PCN: V14-005-00475504-OA

Product Change Notice

Change Type #1: Alternate LED supplier

Change Type #2: Alternative supplier for stacked PCB

Figure 1: Internal layout comparison between current LED and new LED.

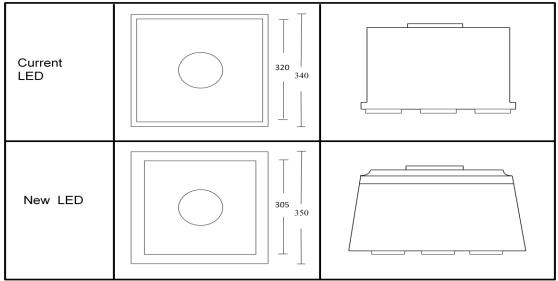
The photos below show the internal layout of the product for both LEDs. The slant wall of new LED is due to different wafer fabrication process, and doesn't affect electrical performance of the product. There's no change to the dimensions of the package.

The change does not affect the performance and reliability of the package. There is no change to the datasheet.

Figure 1: Comparison of the current and new PCBs.

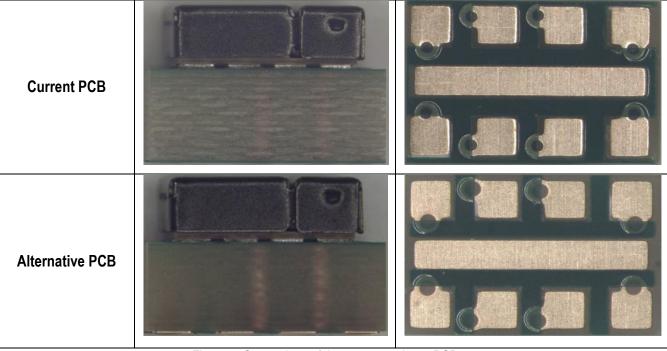
The photos below shows the exterior package of the current devices produced, and compared to the new changed part.

The change does not affect the size and dimension of the package. There is no change to the datasheet.
